**Michael A. Woodbury
Consulting Arborist**

October 1, 2016

Re: Arborist Review Tree Permit #2016-ARP-0047, Review and Recommendations
Site: Kuppens property 17804 28th Ave NE, Lake Forest Park, WA 98155

Figure 1: Tree Protection Fence Drawing.

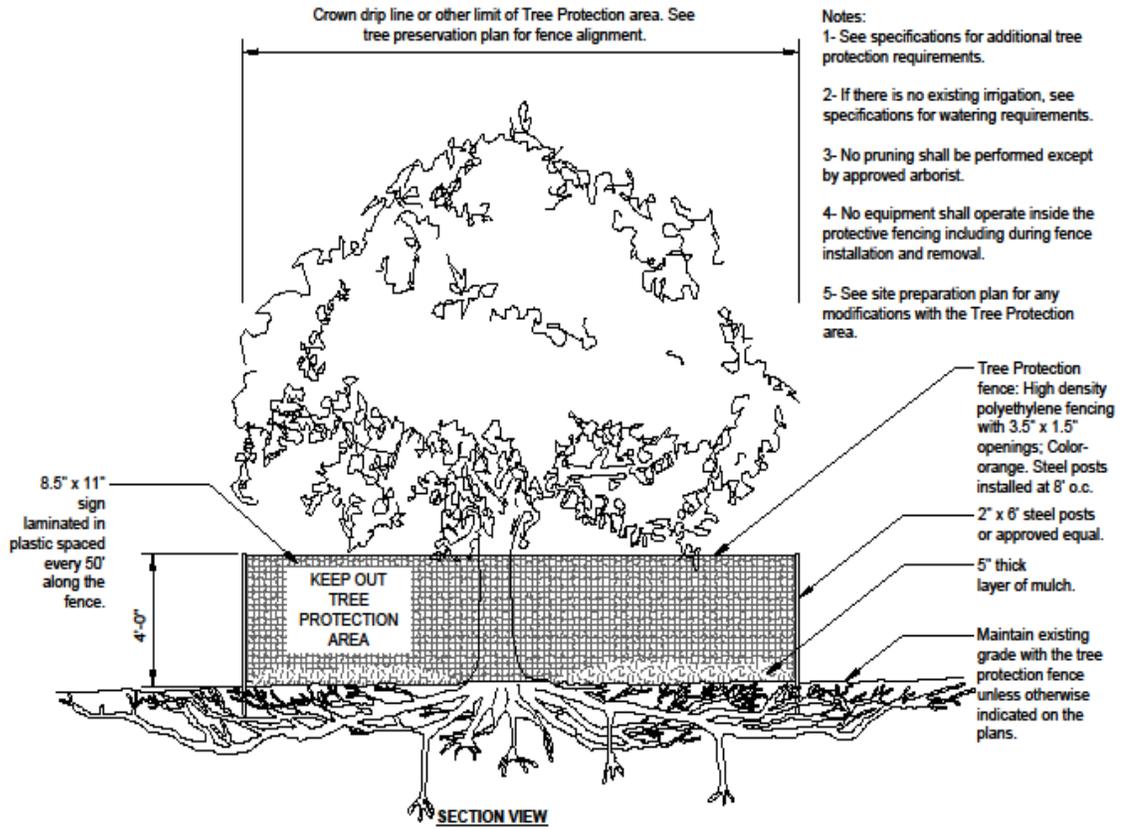
Refer to Figure 1: Tree Protection Fence Diagram.
